**LAKE MANITOBA AND LAKE ST. MARTIN OUTLET CHANNELS PROJECT
RESPONSE TO IAAC TECHNICAL INFORMATION REQUESTS**

Question IAAC-41

QUESTION IAAC-41

EIS Reference: Appendix 6J Development Of Operating Rules For Lake Manitoba and Lake St. Martin Outlet Channels With Recommended Revisions (Manitoba Infrastructure 2019a)

Figure 6.4-4 Fairford River Median Flows (50%) with and without the Project

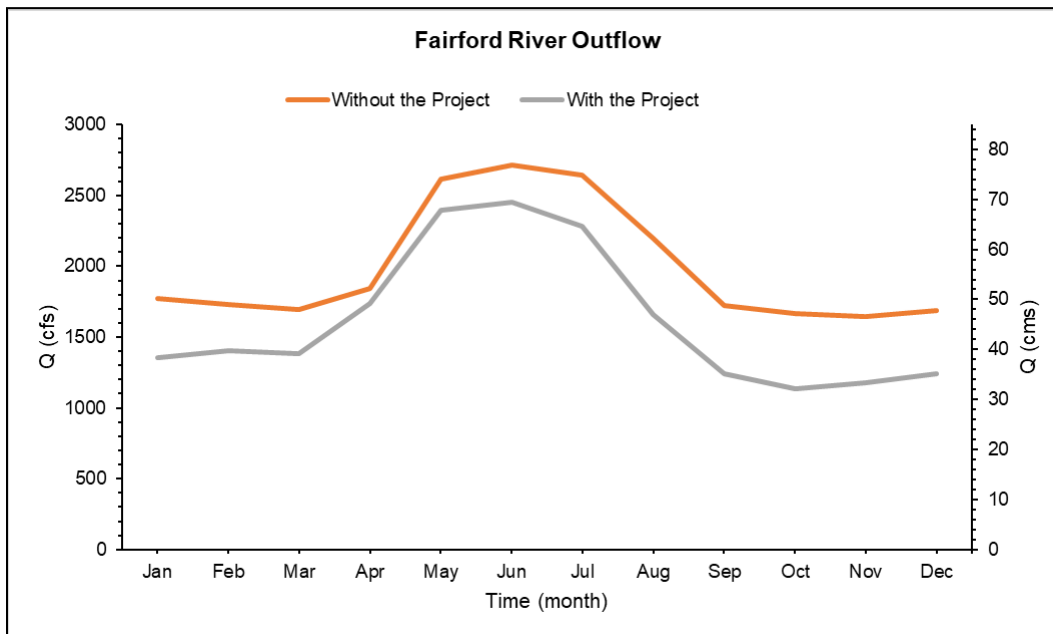
- a) Provide information on proposed flow allocation plans for the outlet channels and the existing Fairford and Dauphin Rivers, and explain how flow allocation was determined.
- b) Identify potential changes to the hydrographs for the Fairford and Dauphin Rivers based on the flow allocation plan with a focus on the potential reduction in higher flow events in the natural rivers and the potential effects of these flow reductions. Describe the effects of these changes to fish and fish habitat, present mitigation measures and provide an updated significance determination.

Reductions in peak flows will occur mainly during periods of high flows, with smaller changes in flow during periods of median and low flows. The flows in the Fairford River system are estimated to be reduced by up to 1.2% during low flow periods, by up to 21.8% during median flow periods, and by up to 31.9% during high flow periods. These percent changes are the estimated total changes in flows at the applicable percent flow exceedance. Changes occur at lower flows due to a carryover effect from a reduction in Lake Manitoba levels due to higher outflows from the Project. To maintain the lake level during low flows once it is lowered, the Fairford River flows are reduced. The median hydrograph for

the Fairford River will be lower with the Project than without the Project but will retain typical seasonal variation, as shown in Figure 6.4-4 in the EIS, which is provided below.
